Final Drainage Letter

7-Eleven Store #42975

PPR File No. PPR2614

Resubmitted: August 2026

Inlet ID: IN-01

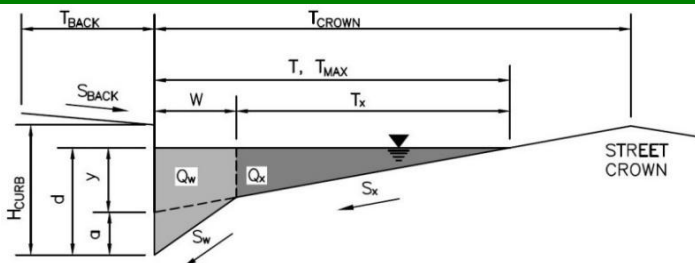
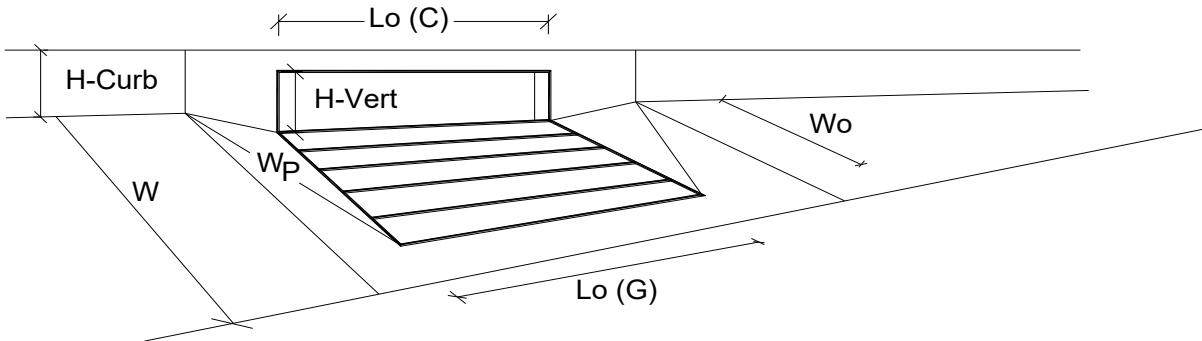
5-year for Minor Peak Flow. Please revise.

Profile Report
Engineering Profile - IN-01-EX MH (STORM.stsw)

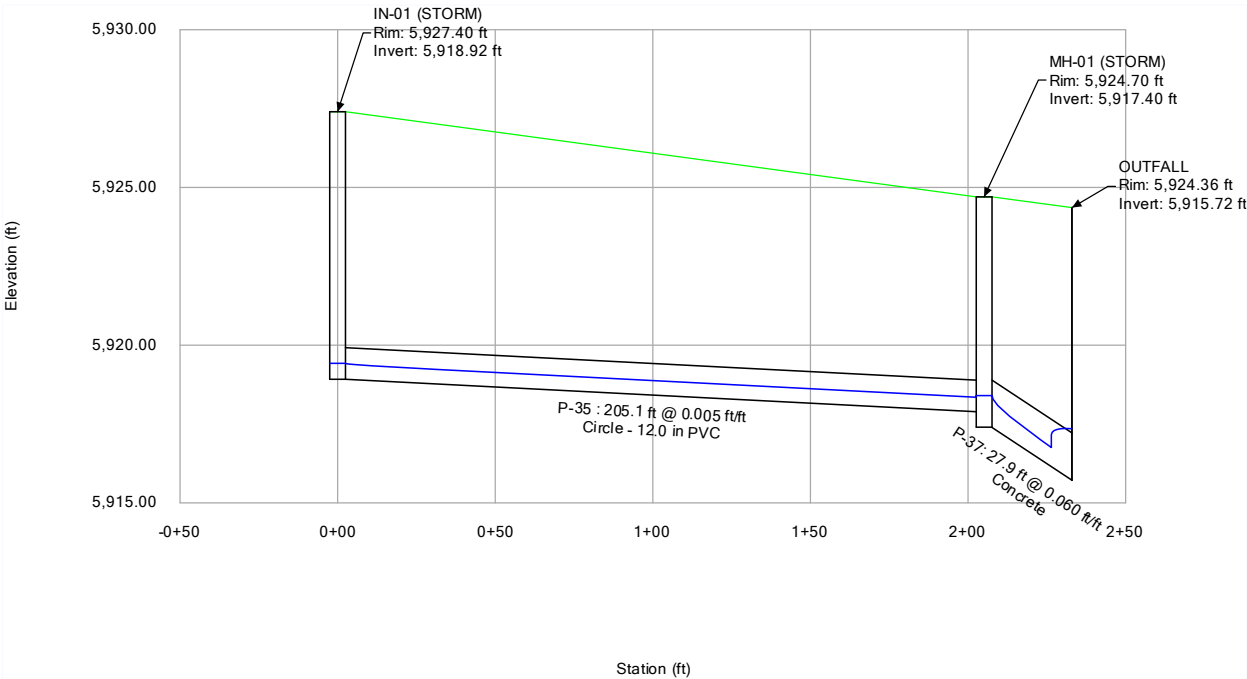
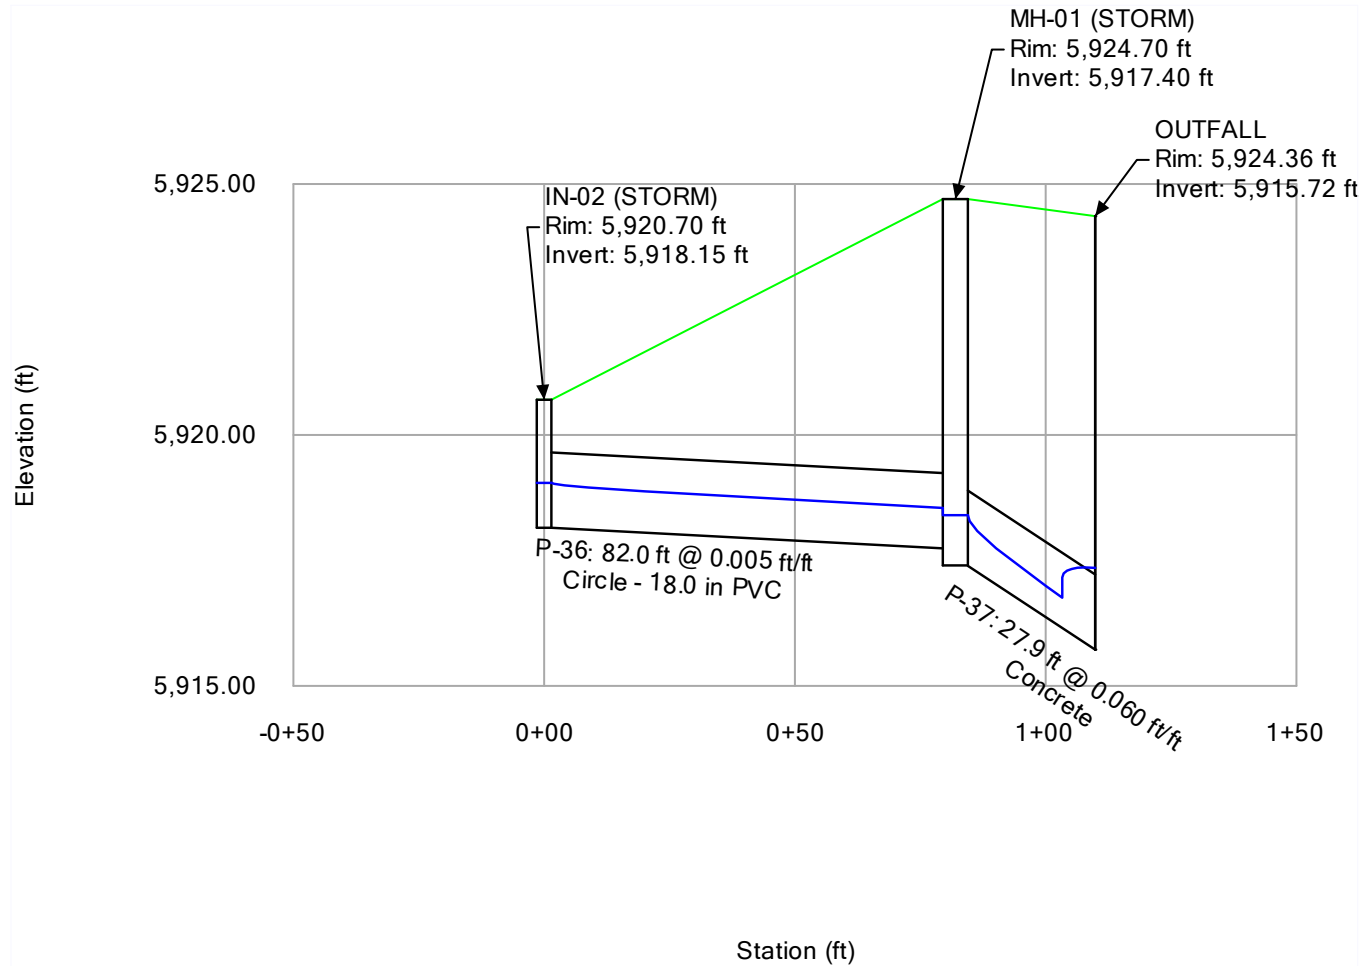
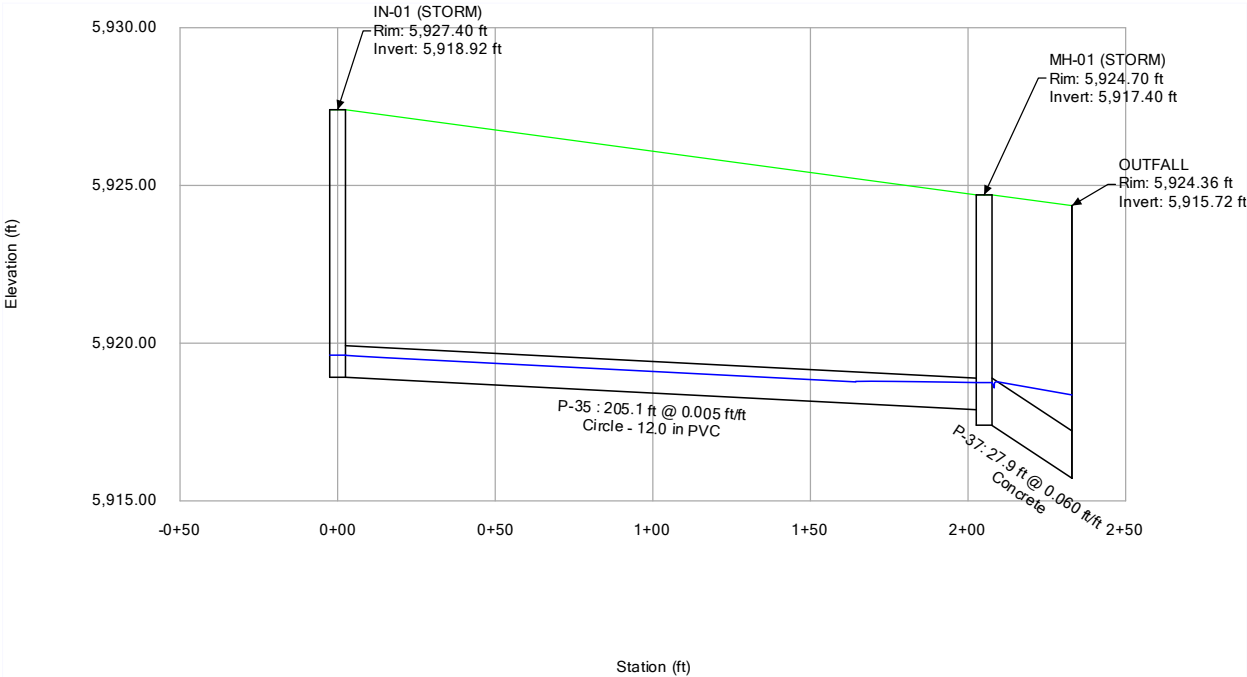
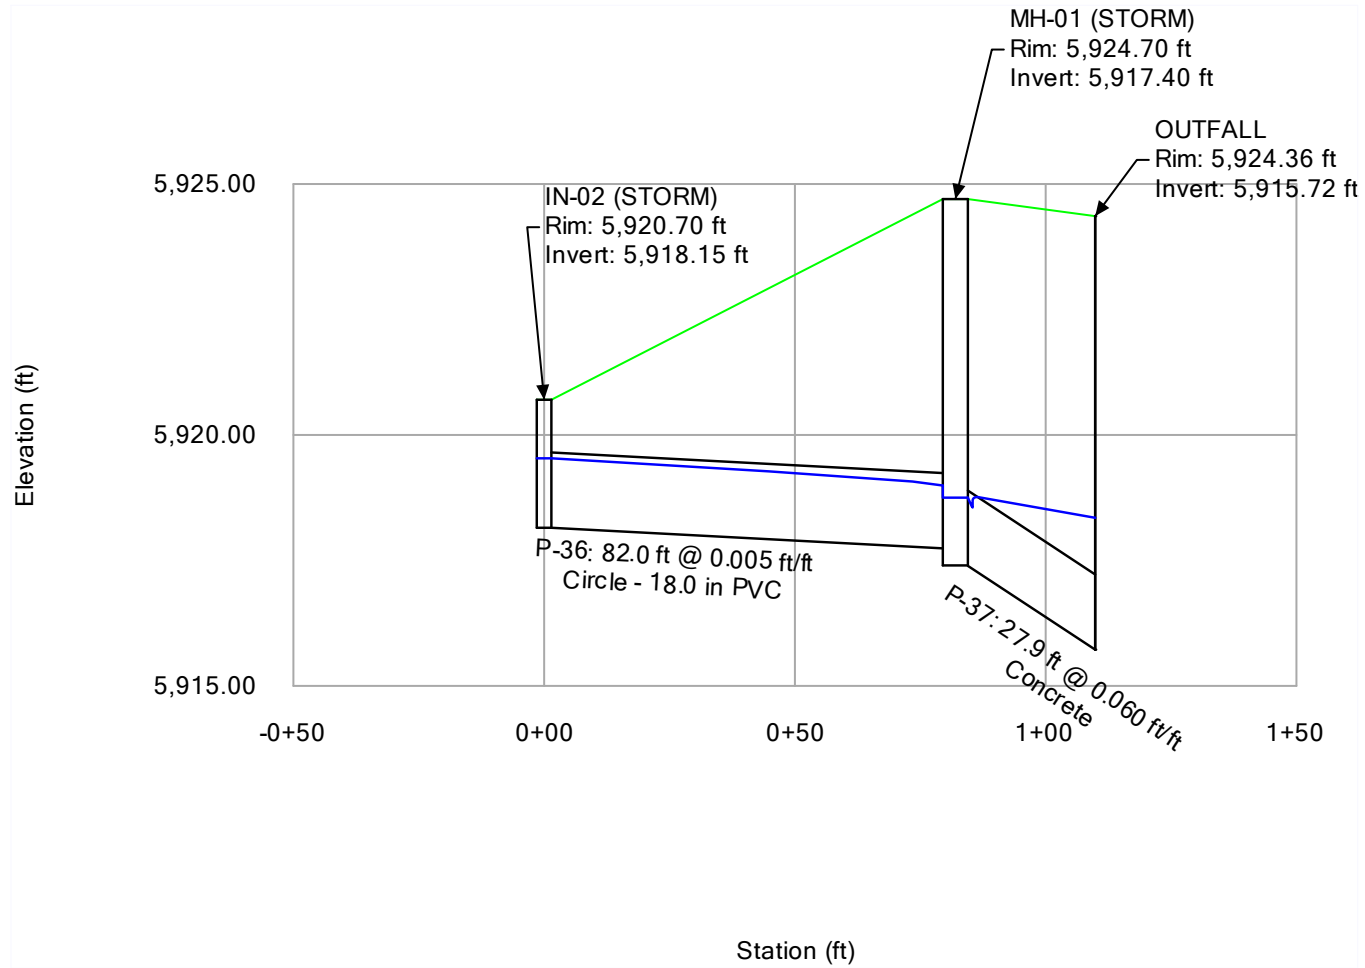
25.4 LF on Sheet
 C4.2. Please revise.

25.4 LF on Sheet
 C4.2. Please revise.

SHEET
DR-1

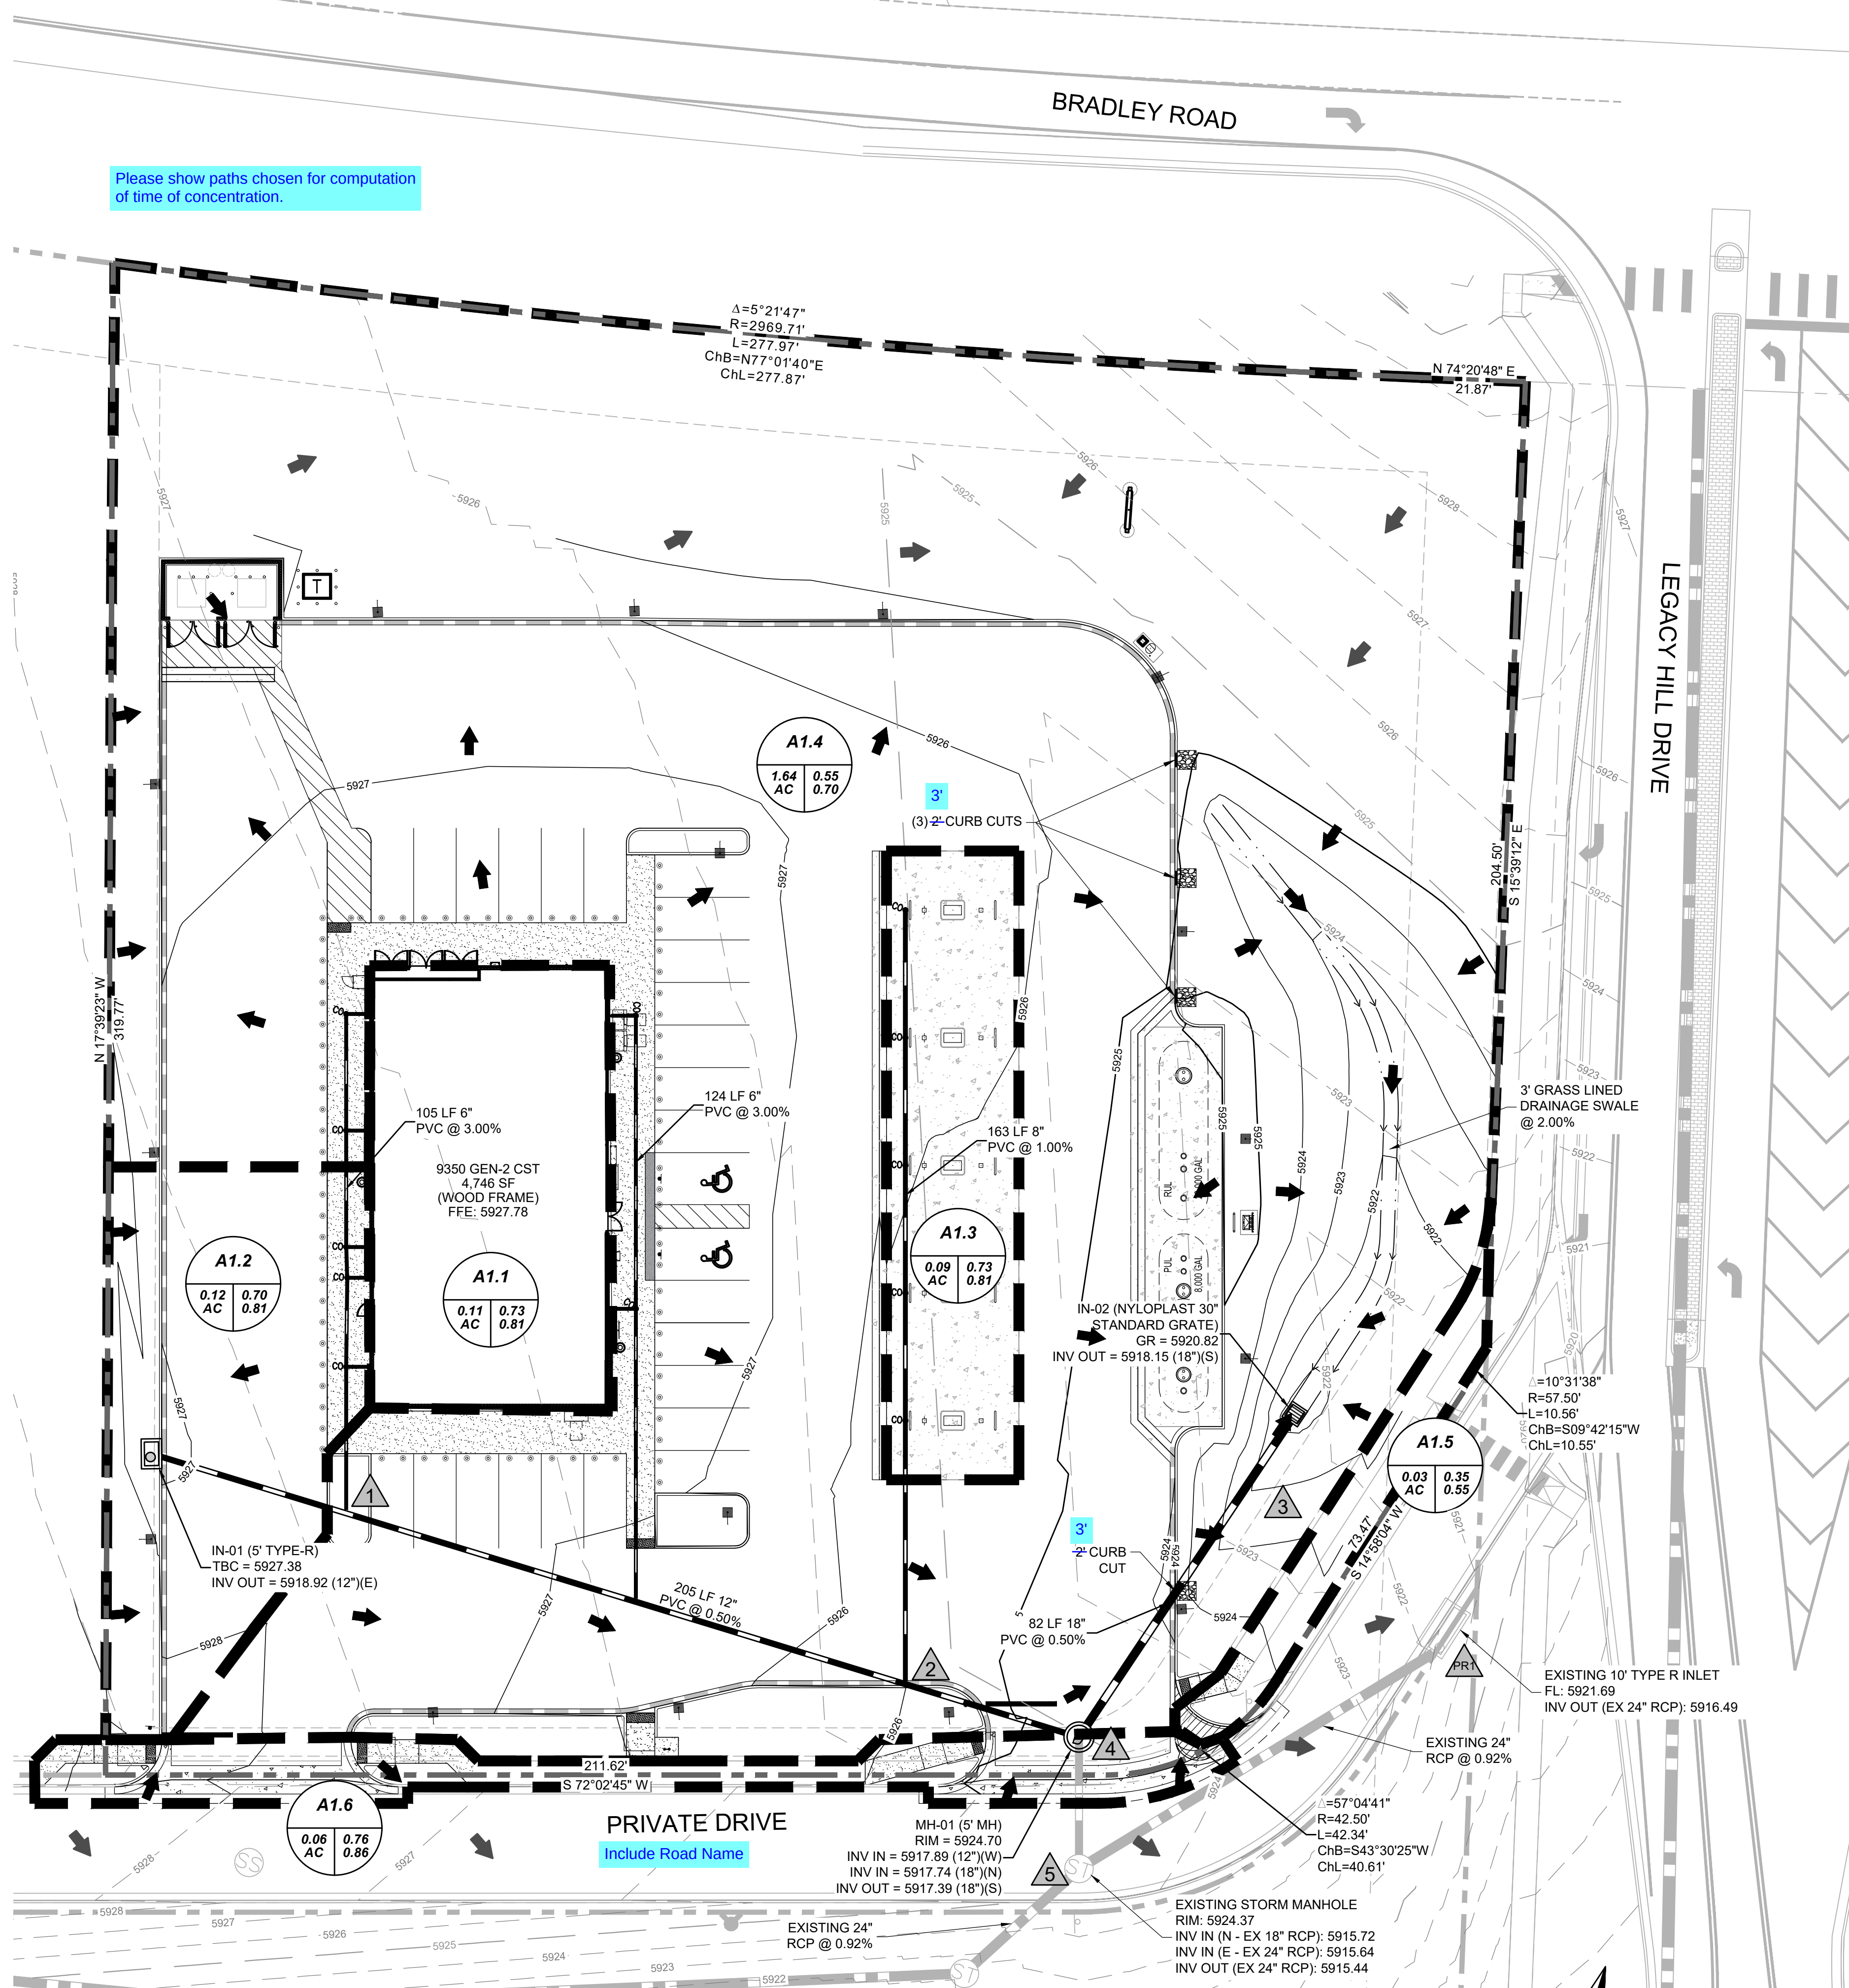
Please show paths chosen for computation
of time of concentration.

These values do not match the Q5 values in the
Developed Conditions Runoff (Q) Table for the
5-year minor storm on Page 15. Please revise.

These values do not match the C5 values in the
Developed Conditions Time of Concentration
Table on Page 14. Please revise.
